Date September 15, 2022
To Town of Cumberland Planning Board
From Carla Nixon, Town Planner
Subject **Final Major Subdivision Plan Review: Snowy Owl Estates**

VI. TOWN ENGINEER'S COMMENTS: Dan Diffin, Sevee and Maher Engineers

Town Engineer Comments:

OLD GRAY ROAD PLAN

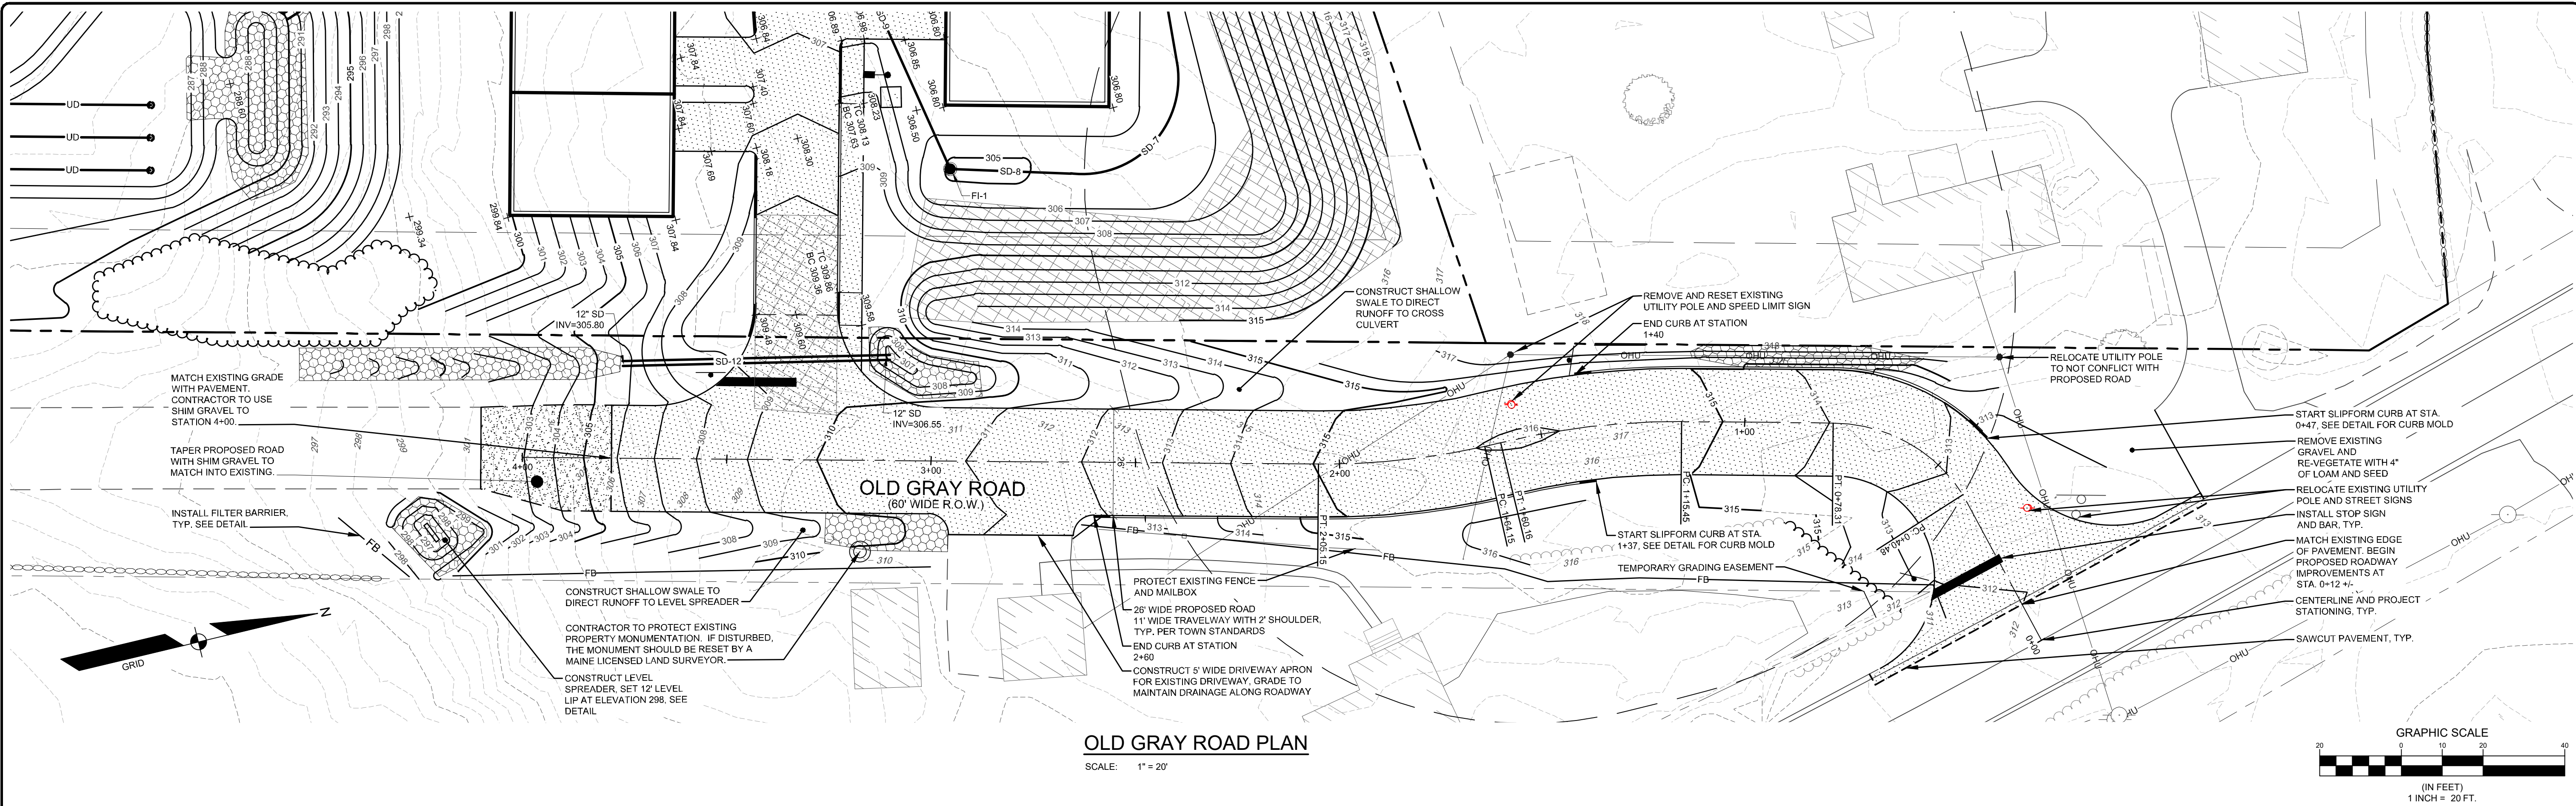
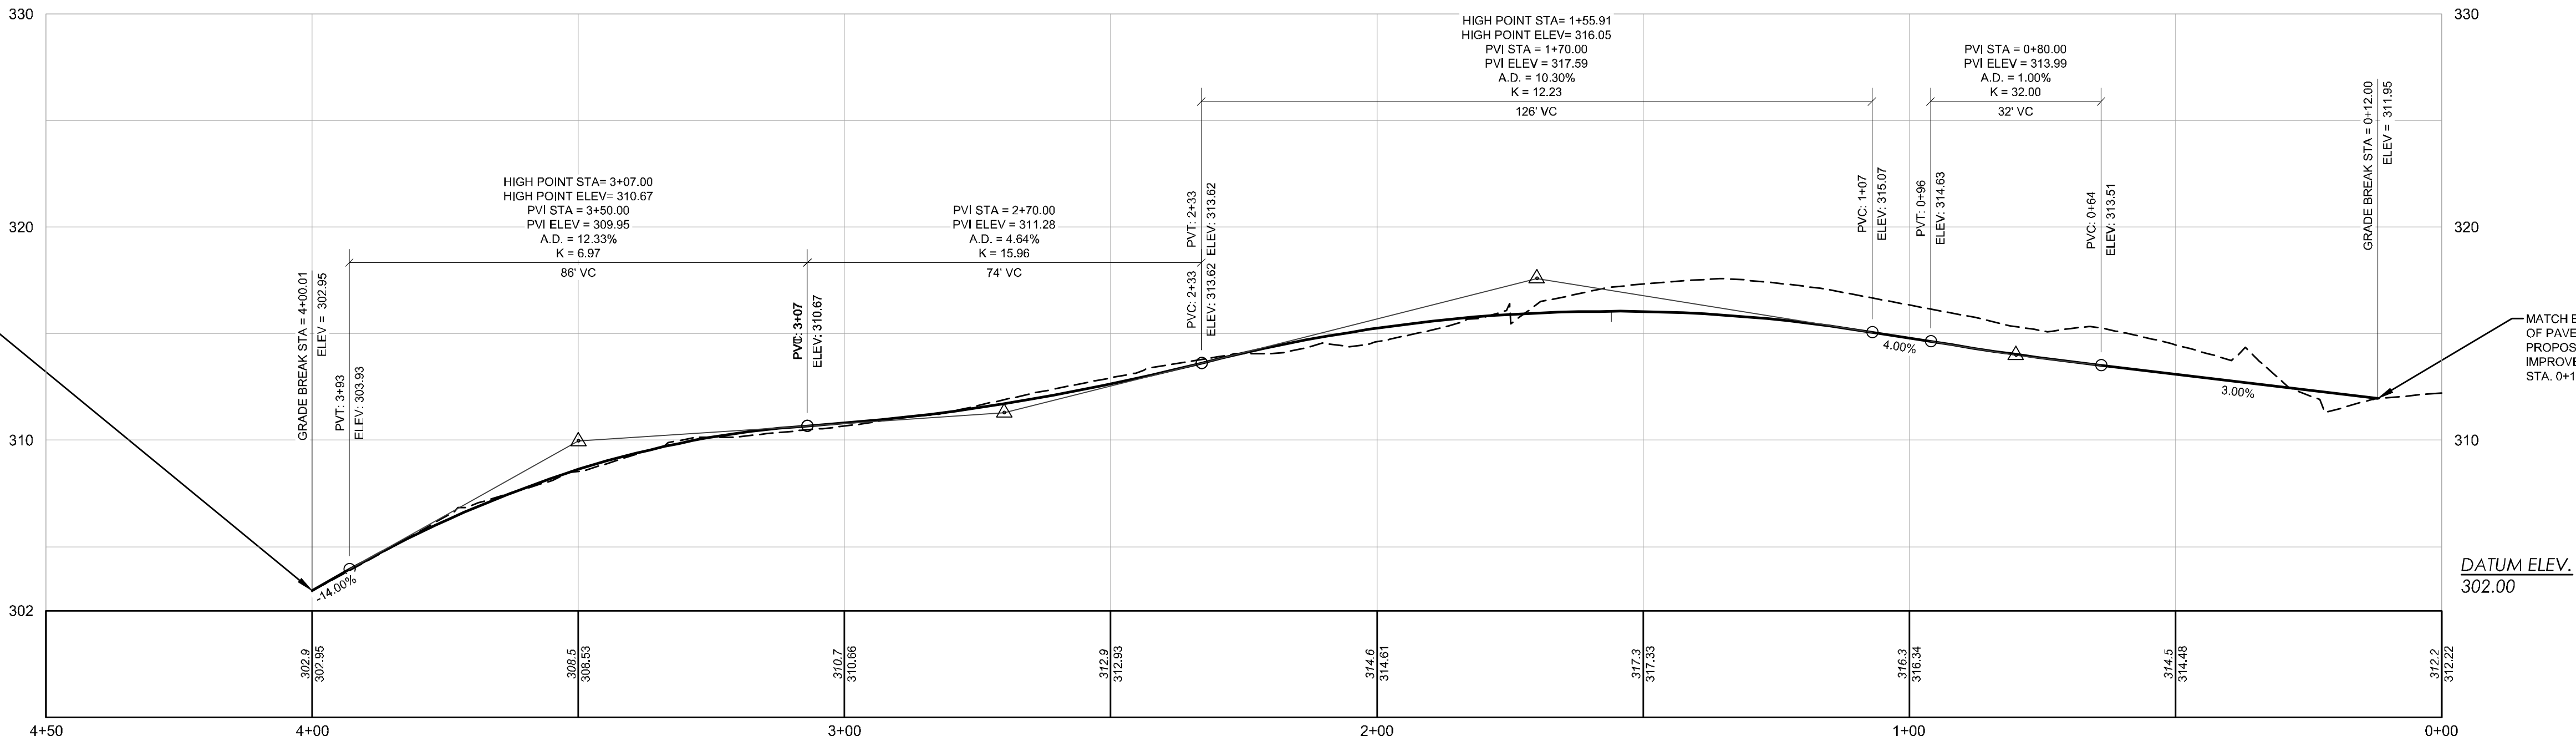
3. The portions of Old Gray Road that access this property do not meet the standards of a Residential Access Street. The construction of the 10-units will require the internal streets and access to the site to meet these standards. SME understands that the applicant is reviewing improvements to Old Gray Road and its intersection with Route 26/100 and will submit the design information with the Final Plan Submission.

Response: Please refer to Sheet 6 of the attached Plan Set for the proposed roadway improvement design.

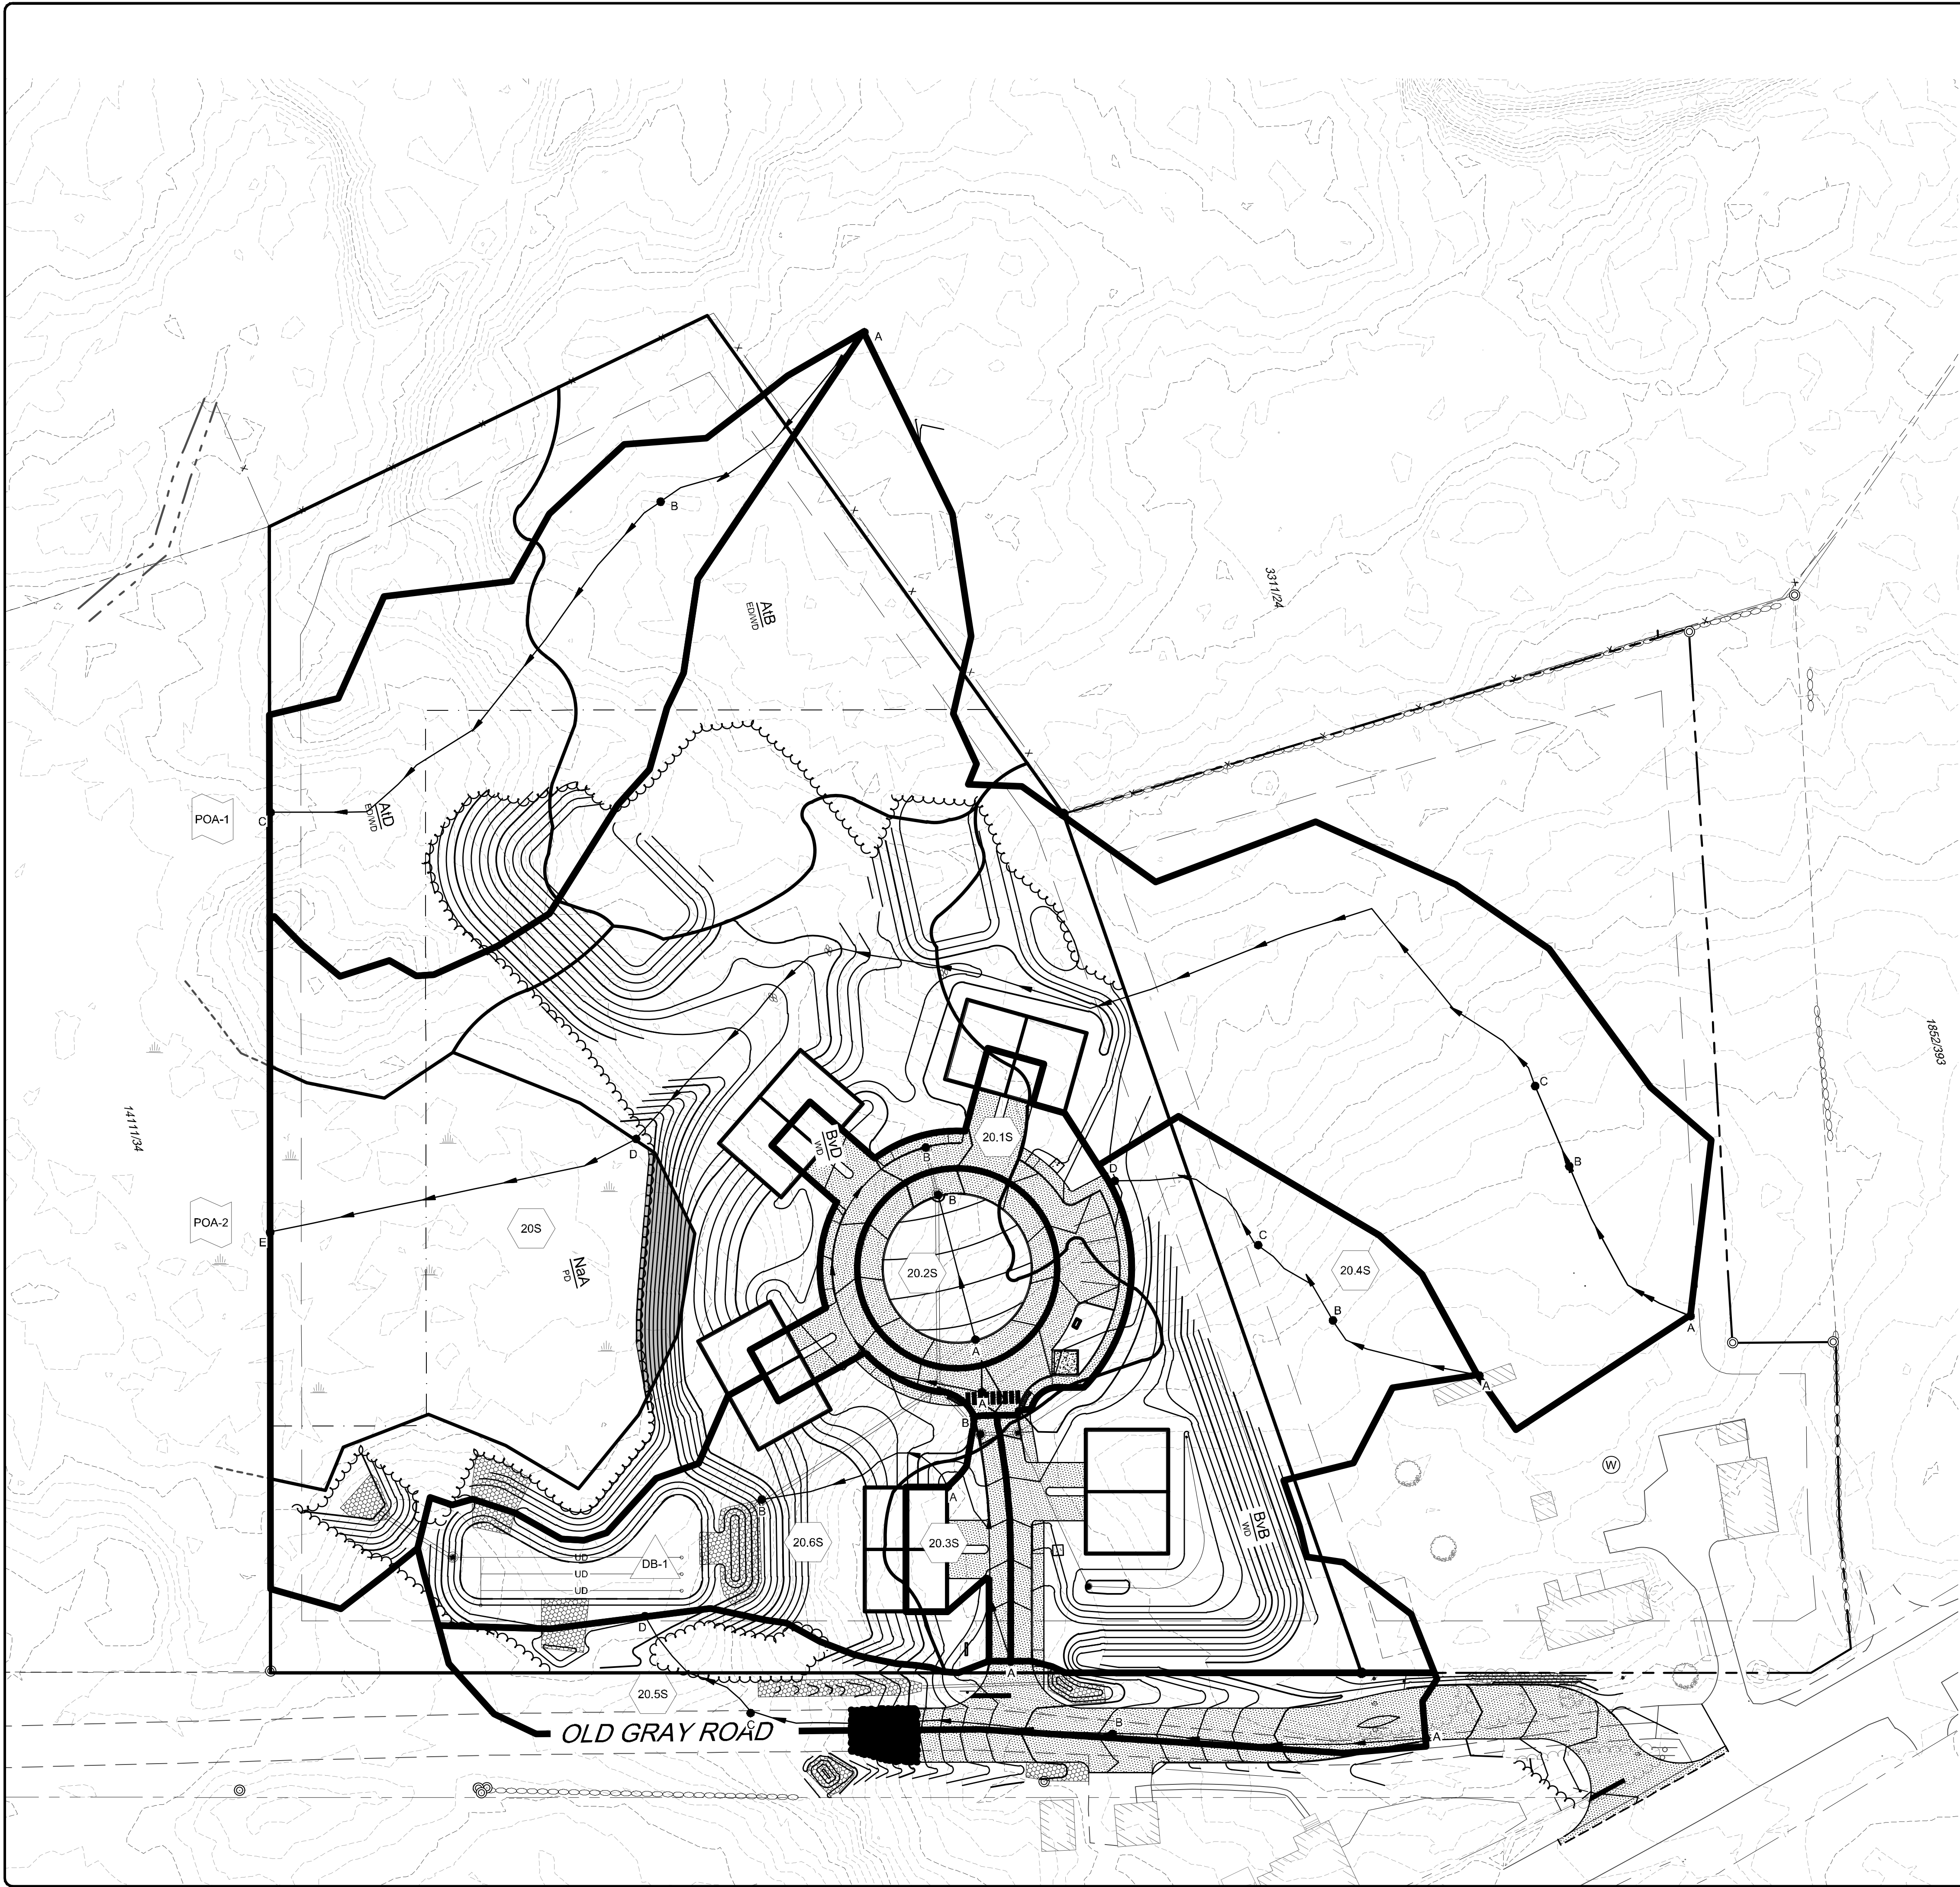
2. The label for Subcatchment 10S is missing from the Post Watershed Plan.

Response: A label for Subcatchment 10S was added to the post-watershed plan.
